SPARC Enterprise M3000/M4000/M5000/ M8000/M9000 Servers

Product Notes for XCP Version 1120

Manual Code: C120-0026-01EN
July 2015, Revision A

M9000 Servers Installation Area

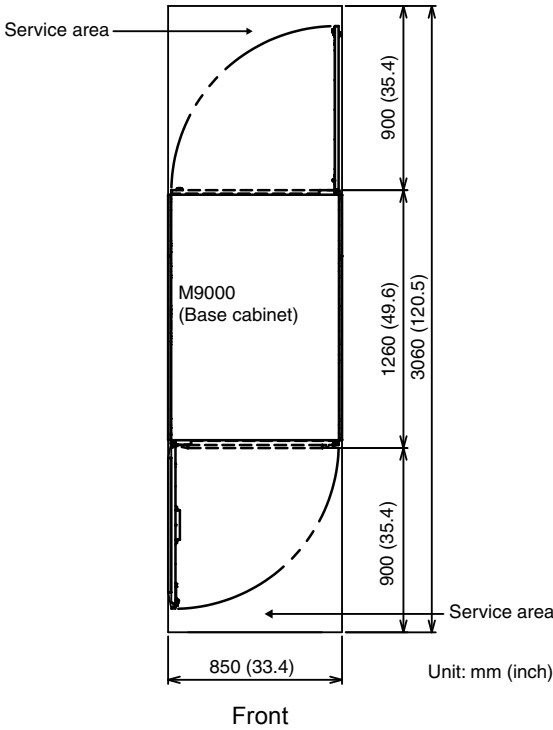
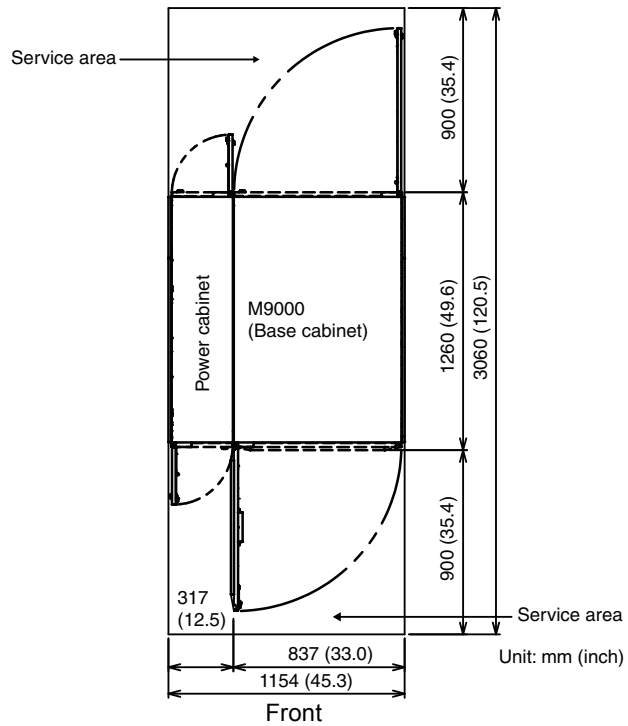
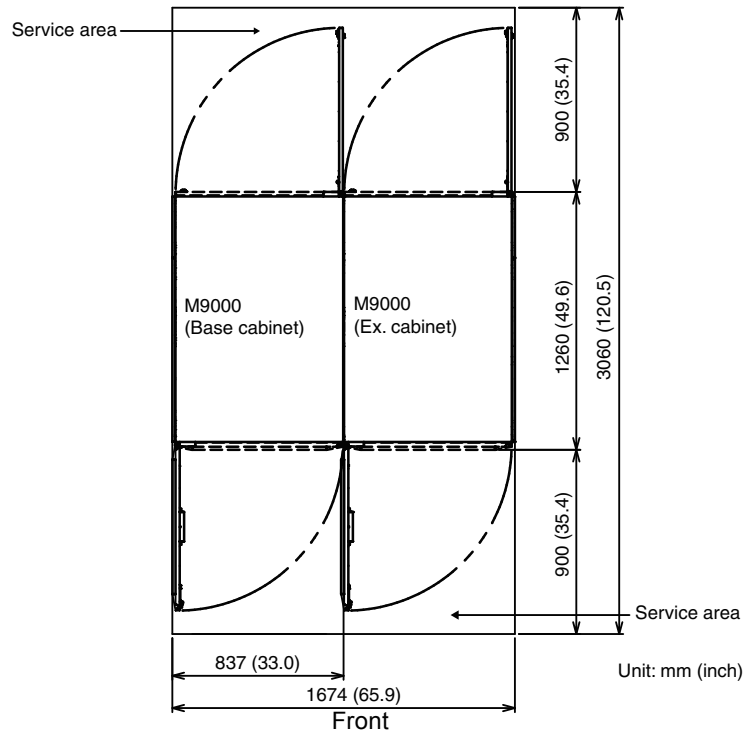
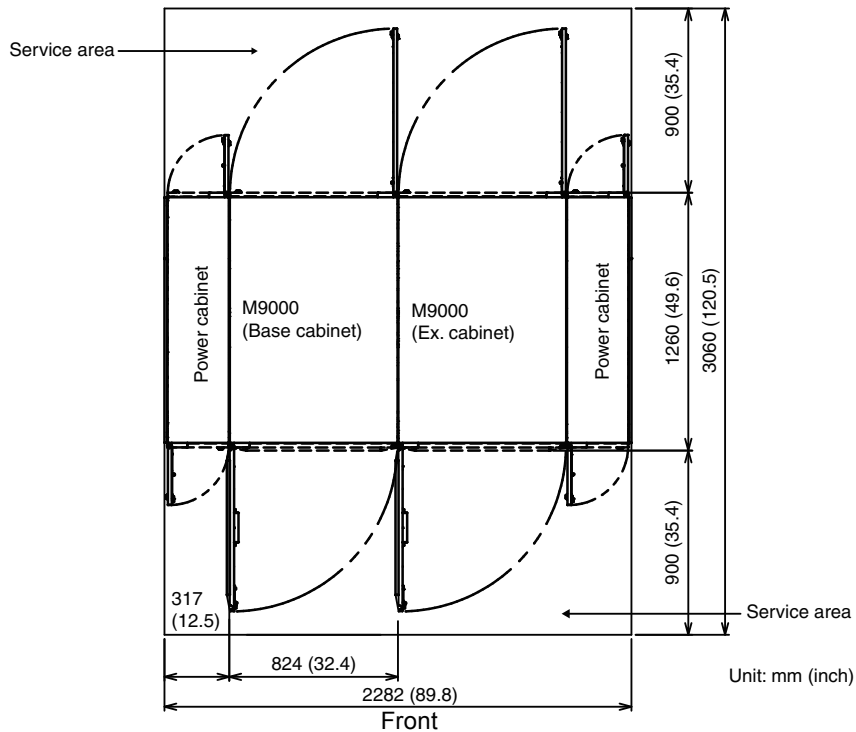
SPARC Enterprise M8000/M9000 Servers Site Planning Guide	1-18	A part of values in inches on FIGURE 1-13 to FIGURE 1-16 will be corrected. For detail, see “M9000 Servers Installation Area” on page 119 .
	1-35	For the order number of Vibration-proof bracket and Vibration-proof feet, see “Miscellaneous Information” on page 123 .
SPARC Enterprise M8000/M9000 Servers Service Manual	7-8	The mounting location of I/O Unit (IOU) indicated on FIGURE 7-4 will be corrected. For detail, see “I/O Unit (IOU) Mounting Locations” on page 122 ."

The following information supersedes the information in the *SPARC Enterprise M8000/M9000 Servers Site Planning Guide*
